Seabrook Station

Response to Request for Additional Information Regarding License Amendment Request to  
Change Applicability of Technical Specification Pressure – Temperature Limits

Response to Request for Additional Information Regarding License Amendment Request to  
Change Applicability of Technical Specification Pressure – Temperature Limits

Figure 1: Comparison of Seabrook WCAP-15745 P-T Limits to Inlet Nozzle Limits

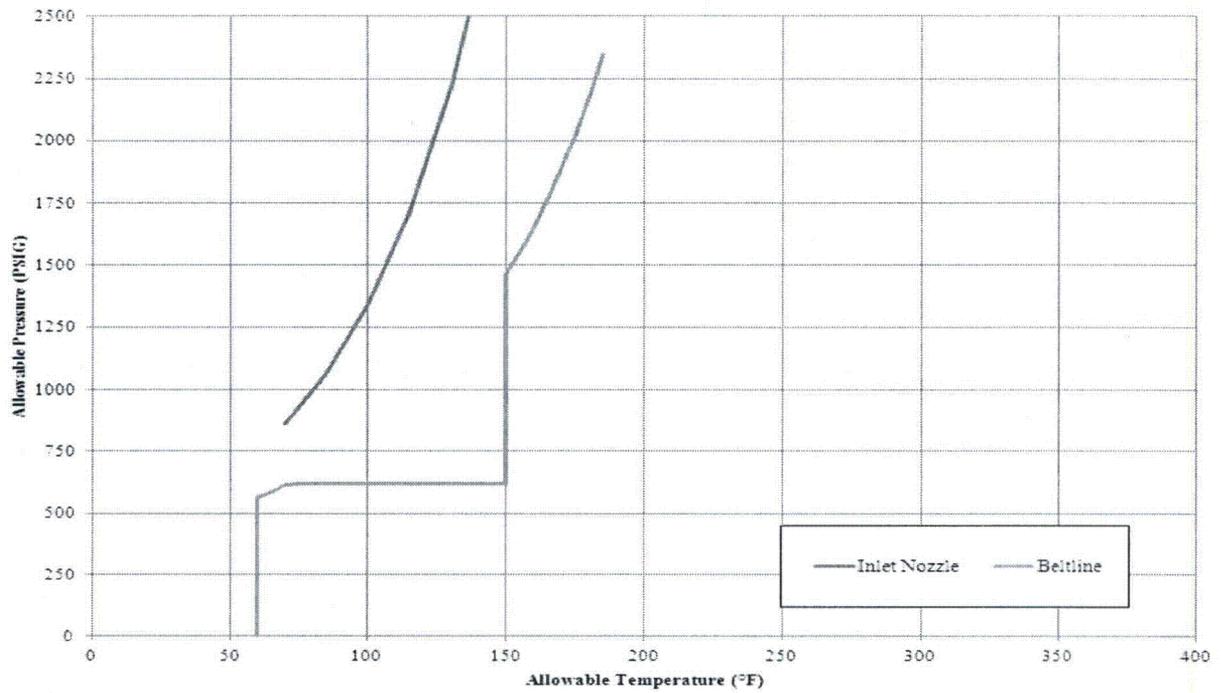
*RV nozzles, penetrations, and other discontinuities have complex geometries that may exhibit significantly higher stresses than those for the RV beltline shell region. These higher stresses can potentially result in more restrictive P-T limits, even if the reference temperature ( $RT_{NDT}$ ) for these components is not as high as that of RV beltline shell materials that have simpler geometries.*

A calculation of the Seabrook nozzle cooldown P-T limits was completed, using the inlet and outlet nozzle Adjusted Reference Temperature properties at 55 EFPY fluence to account for nozzle embrittlement. The stress intensity factor correlations used for the nozzle corners are consistent with the proposed Appendix G Code revision [Reference 7] and ORNL study [Reference 8]. The methodology used included postulating an inside surface ¼ T nozzle corner flaw along with calculating through-wall nozzle corner stresses for a cooldown rate of 100°F/hour.

It should be noted that an outside surface nozzle flaw was not considered. The pressure stress is significantly lower at the outside surface than the inside surface. Further, a stress intensity factor correlation does not exist to consider an outside surface nozzle corner flaw. Therefore, a heatup nozzle P-T limit curve is not provided, as it would be less limiting than the nozzle P-T limit curve in Figures 1 and 2. The resulting nozzle P-T curves, as provided in Figures 1 and 2 were less limiting than that of the 20 EFPY (revised to 23.7 EFPY) cooldown limits in the subject P-T limits contained in WCAP-15745. This demonstrates that the nozzle P-T limits are less limiting and the RV beltline is controlling.
